Independent Pricing and Regulatory
Tribunal (IPART)

Austral & Leppington North and East Leppington Draft Contributions Plans

Review of Stormwater Works - Nexus and
Costs

DRAFT REPORT

Plate 3-1 Raingarden General Arrangement at Intersection (SMEC 2021)

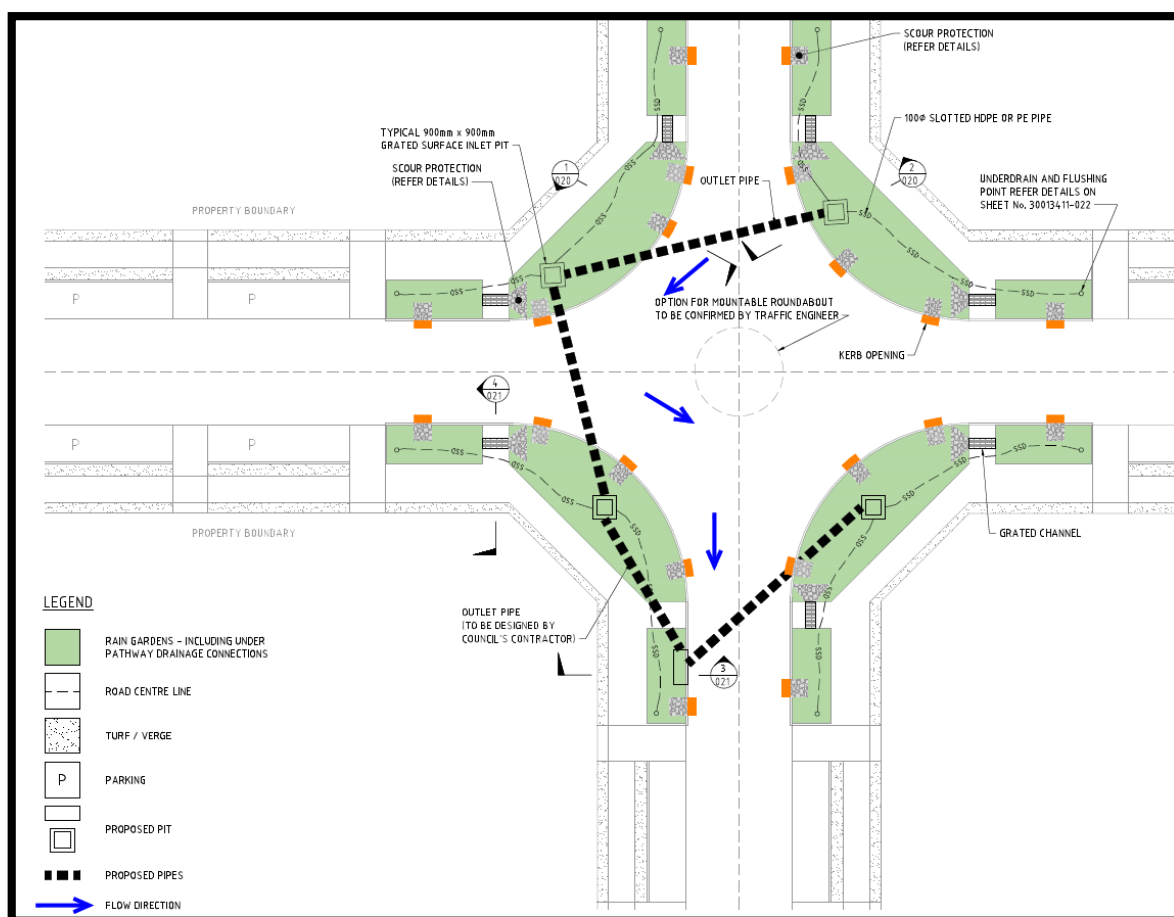
It is noted that our indicative analysis of the cost of streetscape raingardens suggests the cost is around **250 % higher** than Council's allowances in the contributions plan.

For streetscape raingardens, the cost review is aligned with the SMEC concept design for a 4-way intersection (refer to Plate 3-1) Cost rates were reviewed and adjusted where there was a significant rate difference identified. Some additional work components were added where this was deemed appropriate to fully define likely costs or to reflect the raingardens construction delivery staging.

Item	SMEC total direct cost estimate	JWP total direct and indirect cost estimate	Indicative cost change	Indicative cost change %
4-way intersection	\$116,471	\$298,580	\$182,109	256%

Plate 6-1 – Case Study Catchment Drainage System NB11_P4_01 (SMEC 2021)

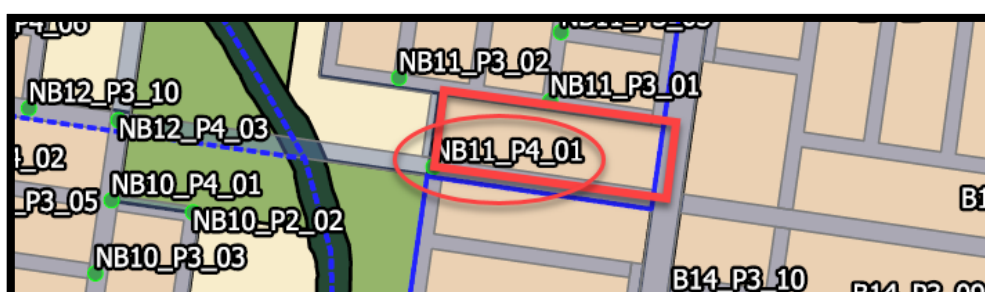
It is uncertain as to whether the street level controls presented in the concept report (SMEC, 2019) or the masterplan (SMEC, 2021) have considered the safety aspects of managing flow widths within the local streets. The typical MUSIC (stormwater quality model) catchment in the Concept Report (SMEC, 2019) suggests that the bio-filters at intersections will cater for full upstream street catchments entering the raingardens as surface flow. In our experience as civil and stormwater design engineers, numerous pits and pipes are required within the street network to ensure gutter flow widths in the road comply with Council safety standards and that flow depths and velocities are safe for pedestrians and vehicles up to 1% AEP storm event. If these traditional road safety standards are to be complied with (which would be expected as part of any development application

As a case study, we have considered an example catchment from the Streetscape Masterplan (SMEC, 2021) study which drains to the corner of Eighth Avenue and Pyncheon Street in Austral. The catchment has an area of approximately 2.1 ha and is bound by Polbar Street to the north, Eighth Avenue to the south, Pyncheon Street to the West and Edmondson Avenue to the east. Plate 5-1 below provides an overview of the location as shown in the Masterplan, and Plate 5-2 provides an overview of the catchment extent, elevation contours, and current land zoning.
